From: Bryan Reiter [bryanreiter@pmt.org]
Sent: Thursday, March 31, 2016 3:54 PM
To: Nelson, Dan
Subject: RE: Water right 45-13411

RE: Additional Information Request for Permit 45-13411

Therefore, **I will need documentation that shows the Peak Instantaneous Demand (PID) in gpm or cfs for the entire municipal system including the irrigation and culinary systems.** We are only allowed to consider the amount of water diverted during the development period for water right permit 45-13411, which was from 2001 to 2008. We have been able to use water district records to come up with a rough estimate, but we feel you may have better records to provide a more concise determination of the PID.

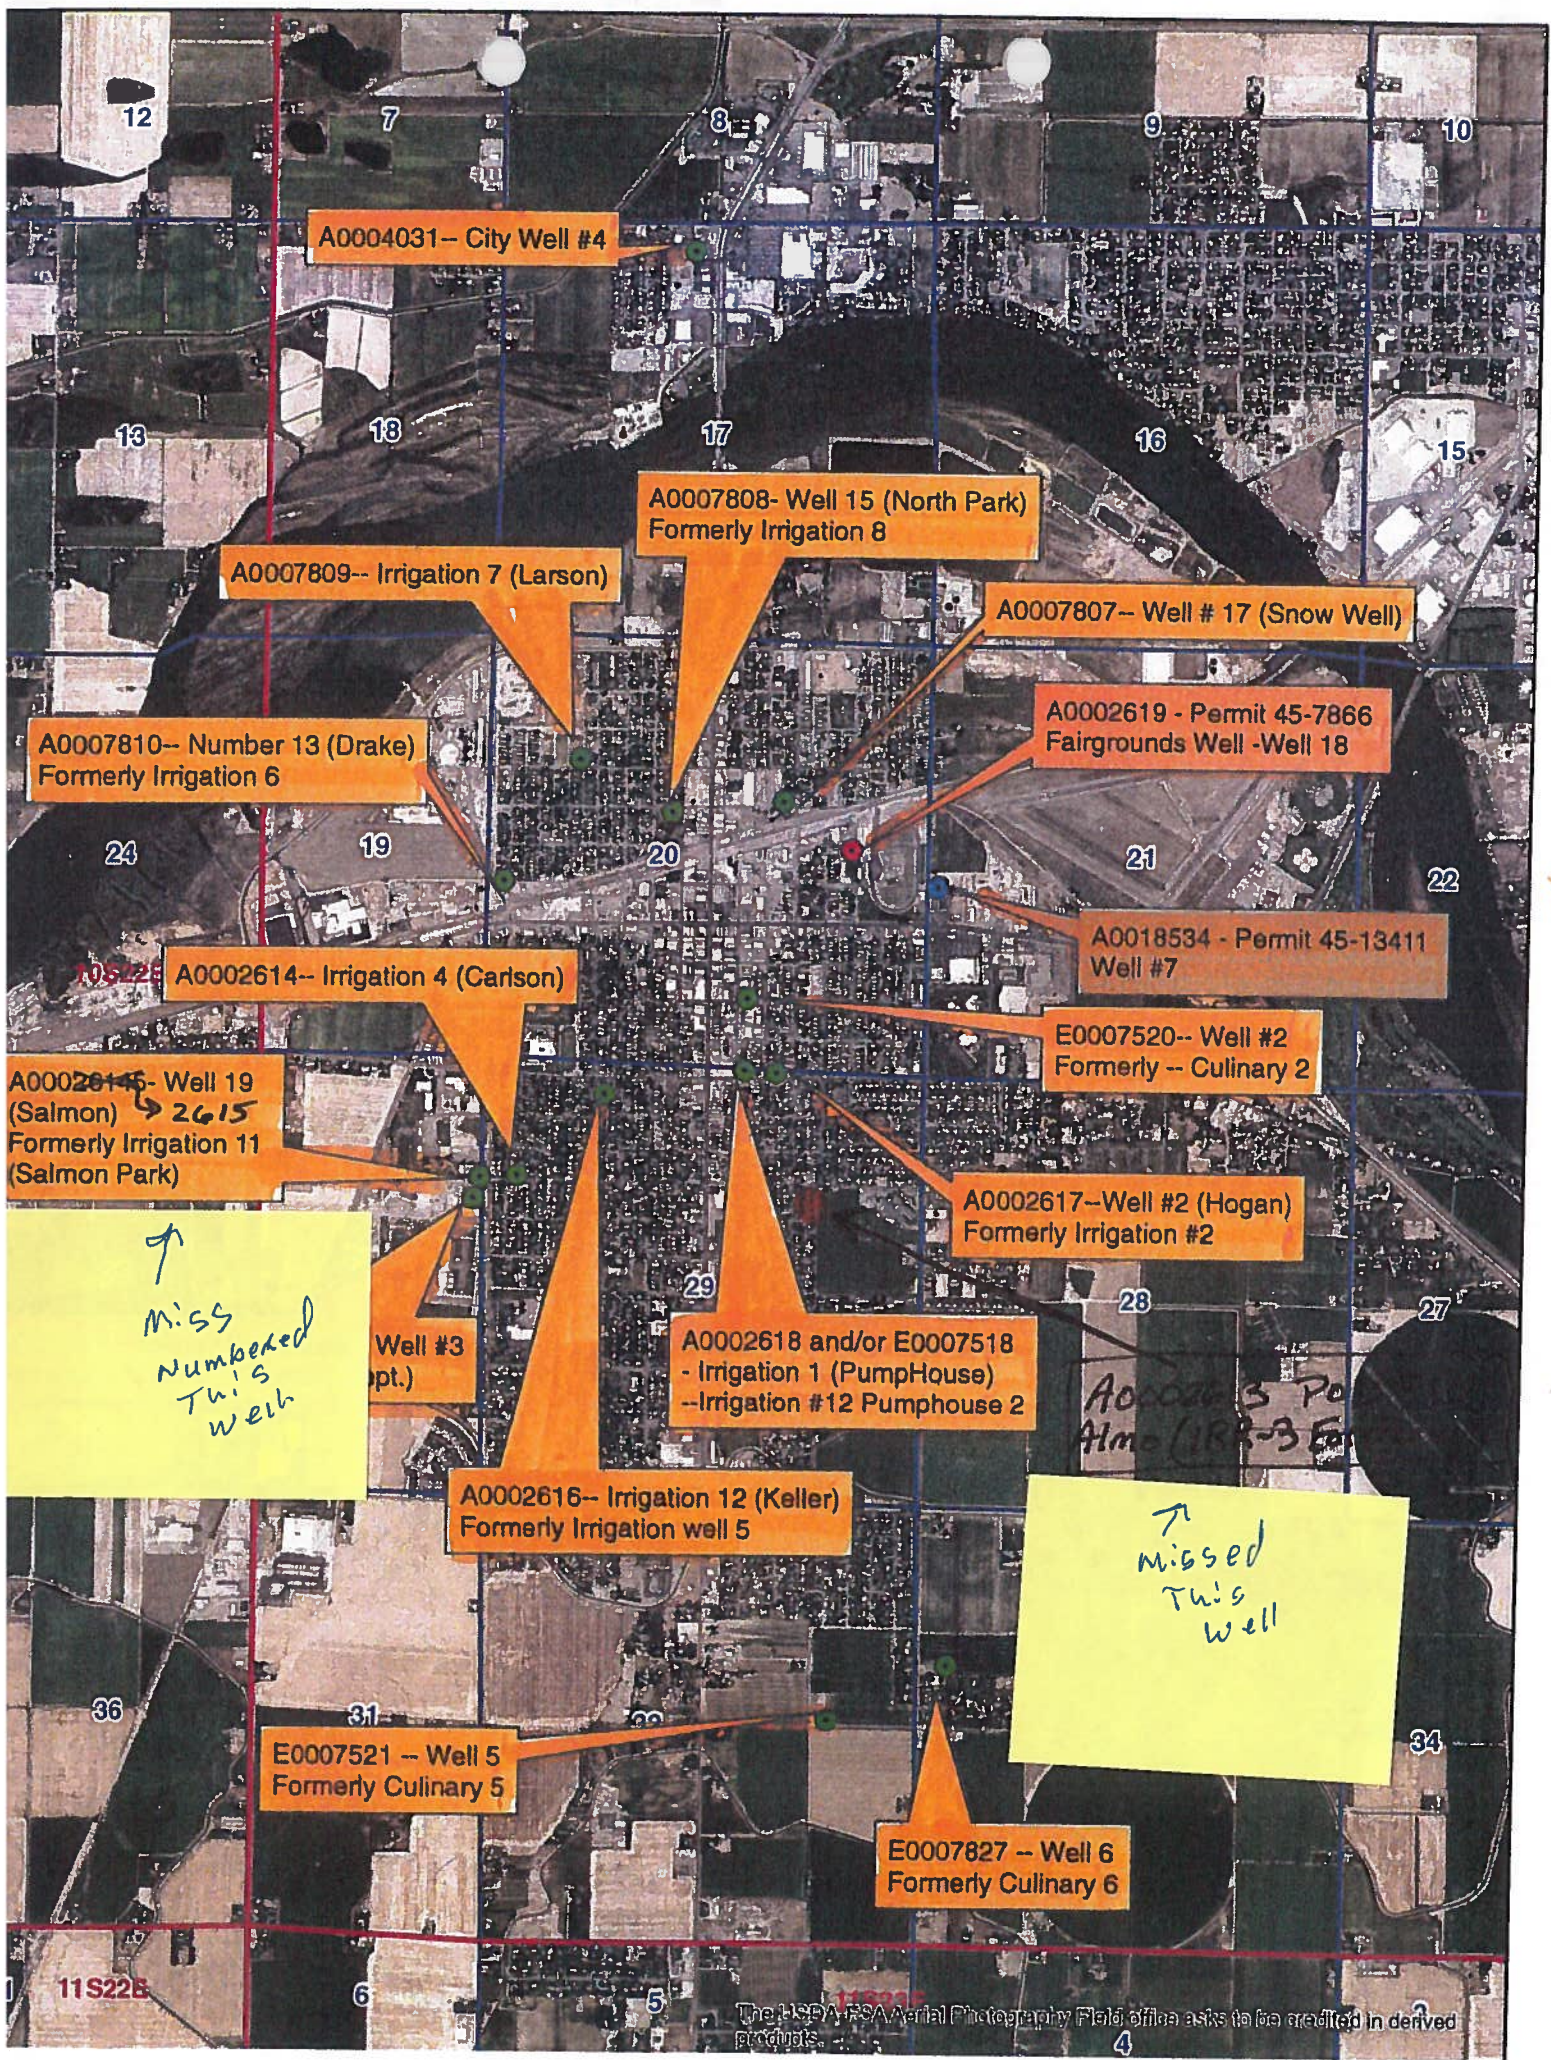
Dan,
I am reviewing the information requested about water right 45-13411. In the letter you asked about verification of the map. I have attached a marked up map with two revisions that I noticed.

One, POD #10, Almo Well, formerly IRR-3, tag #A0002613 is not shown on the map. It is located in the southwest corner of 19th and Almo.

Two, the tag number for the Salmon well is A0002615, rather than A00026145.

*Miss
Numbered
This
Well*

*A0002618 Po
Almo (IR-3 En*

*Missed
This
Well*

Thank you for the updates on the map. I checked our maps and database information, and I agree with the corrections you made on the map. I will make sure they are corrected in the final documentation.
